BRUNSWICK STEAM ELECTRIC PLANT, UNIT NOS. 1 AND 2  
DOCKET NOS. 50-325 & 50-324/LICENSE NOS. DPR-71 & DPR-62  
RESPONSE TO REQUEST FOR ADDITIONAL INFORMATION  
MISCELLANEOUS TECHNICAL SPECIFICATION REVISIONS

RESPONSE TO REQUEST FOR ADDITIONAL INFORMATION  
MISCELLANEOUS TECHNICAL SPECIFICATION REVISIONS

Re: CP&L Request for License Amendment Dated September 7, 1982;  
Attachments 7 and 8

ATTACHMENT 3  
ISOLATION LOGIC DIAGRAMS

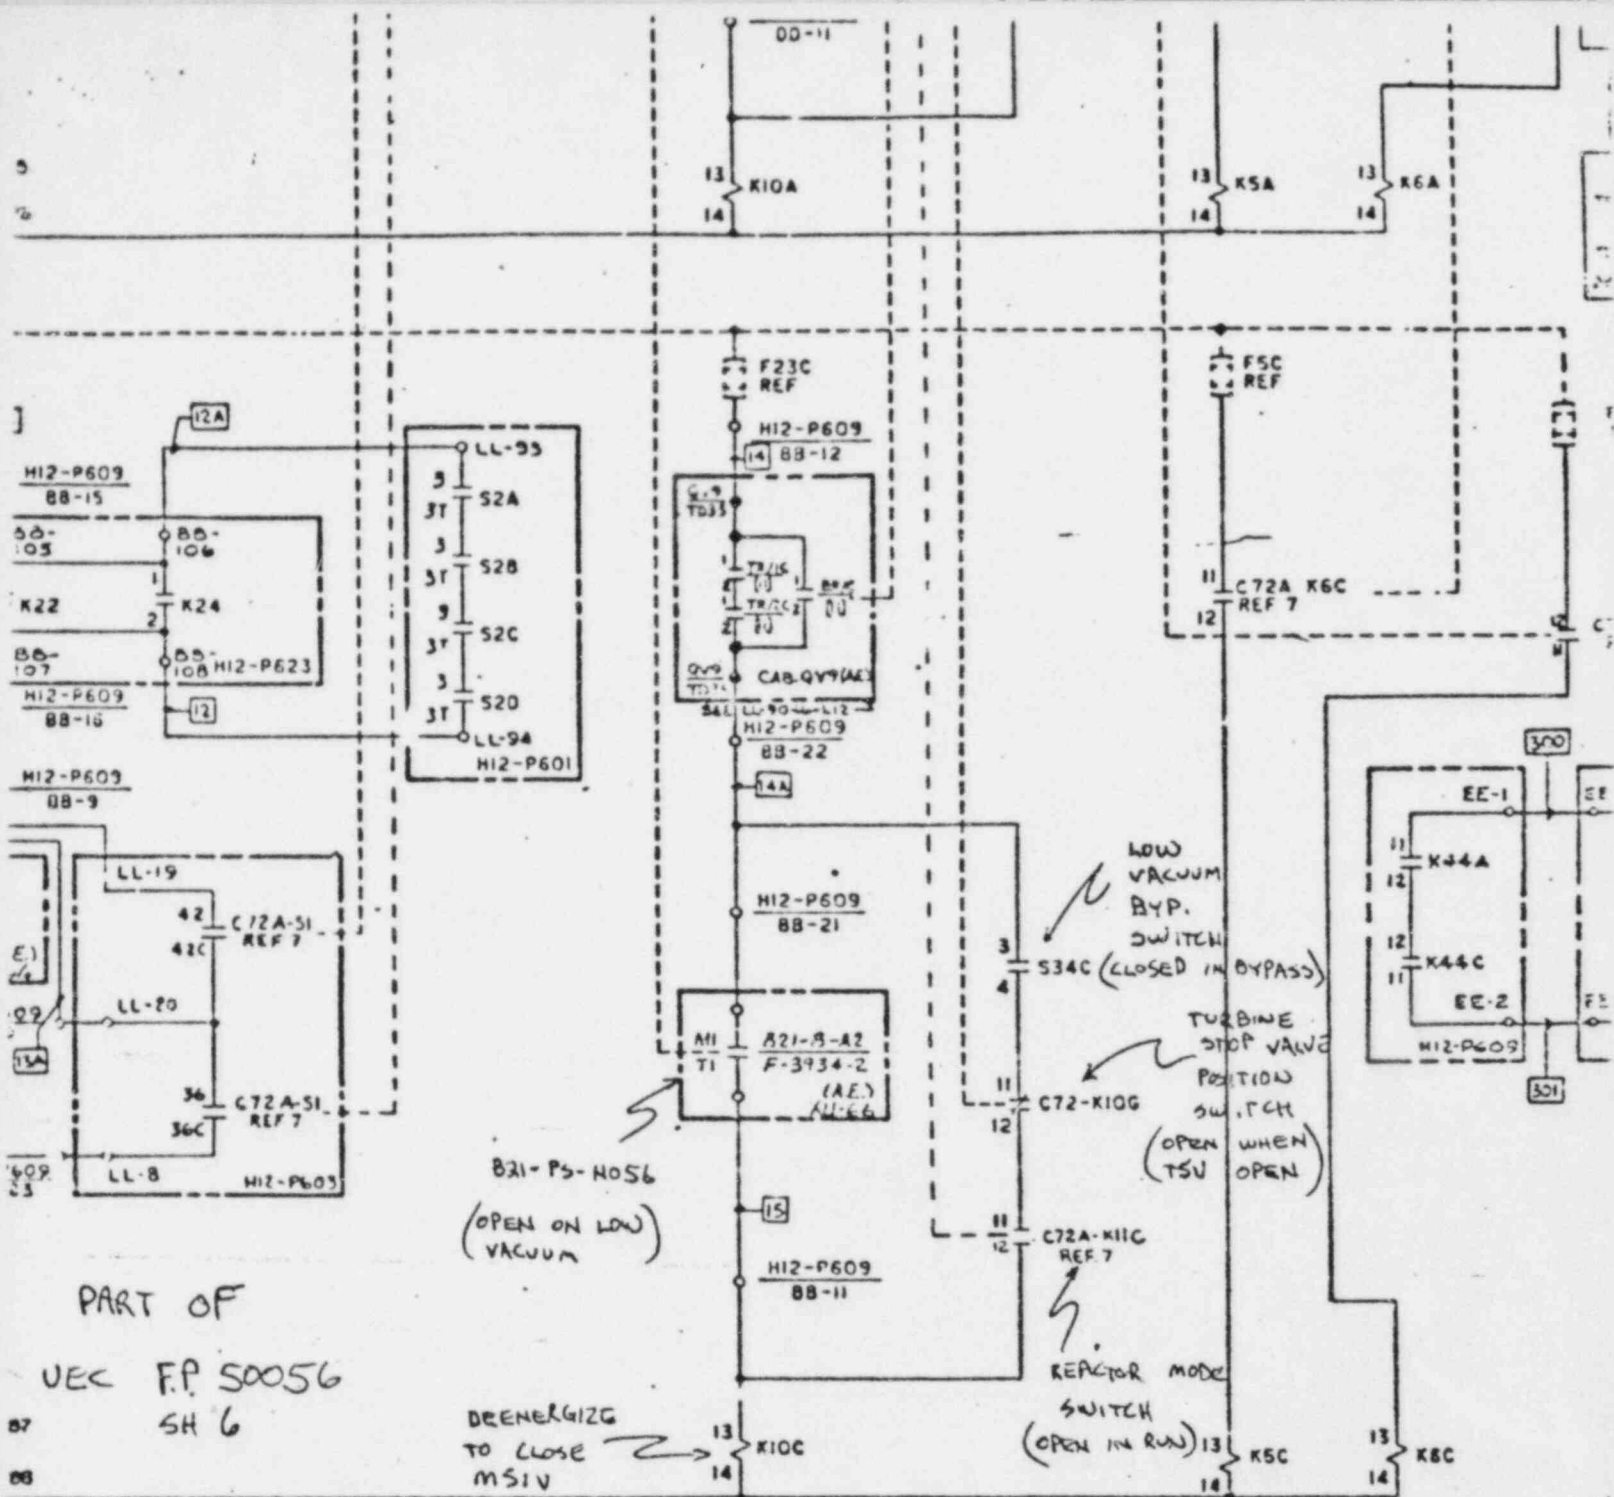
- 8.1 State the objective of this change.
- 8.2 State the intended purpose of this bypass and discuss the procedures that would be established to control its use.
- 8.3 Consider the inadvertent use of this bypass including its consequences and the means for avoiding inadvertent bypassing.
- 8.4 Please provide clear diagrams of all isolation logic to be bypassed and show how reactor operation would be affected.

See Attachment 3.
